Access Compliance Report Public Rights-of-Way (Curb Ramps)

Main Street: FOSTER_RD Cross Street: COPA_DE_ORO_DR Location: NE

ADA ID: RPRK211207123004 Ramp Type: Type 4 - Parallel Initial Pass/Fail: Fail Overall Compliance: No Severity Score: 15

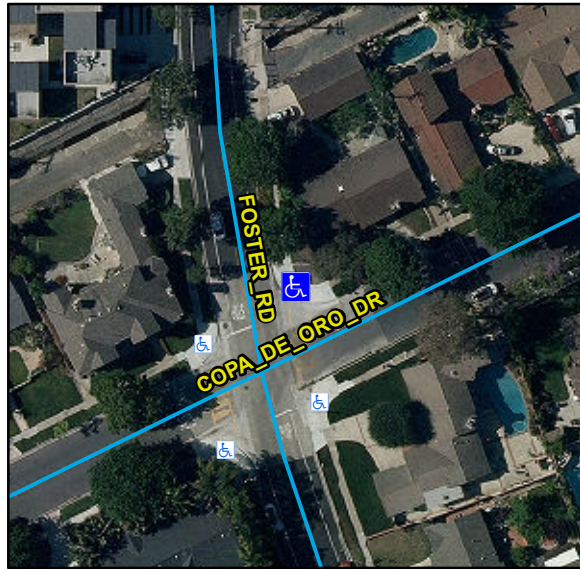
Compliance	Description	Data	Compliance	Description	Data
N/A	Ramp Length LT (in)	68	N/A	Ramp Length RT (in)	94
Yes	Ramp Width LT (in)	68	Yes	Ramp Width RT (in)	68
Yes	Ramp Run Slope LT (%)	2	Yes	Ramp Run Slope RT (%)	7
No	Ramp Cross Slope LT (%)	2.6	No	Ramp Cross Slope RT (%)	6.4
N/A	Landing Present	N/A	N/A	DWS Provided	N/A
N/A	Landing Length (in)	N/A	N/A	DWS Contrast	N/A
N/A	Landing Width (in)	N/A	N/A	DWS Length (in)	N/A
N/A	Landing Run Slope (%)	N/A	N/A	DWS Full Width	N/A
N/A	Landing Cross Slope (%)	N/A		DWS Offset Type	N/A
N/A	Landing Movement Obstructed?	N/A	N/A	DWS Offset Left (in)	N/A
	Landing Movement Type	N/A	N/A	DWS Offset Right (in)	N/A
N/A	Landing Shared	N/A			
N/A	Clear Space	Yes			
N/A	Clear Space To Crosswalk (in)	N/A			
N/A	Marked Crosswalk 1	No	N/A	Marked Crosswalk 2	Yes
	Crossing 1 Direction	W		Crossing 2 Direction	S
	Marked Crosswalk 1 Width (in)	N/A		Marked Crosswalk 2 Width (in)	144
N/A	Ramp Inside Crosswalk 1	N/A	N/A	Ramp Inside Crosswalk 2	Yes

Remove & Replace Curb Ramp With Two New Directional Ramps or Equivalent.
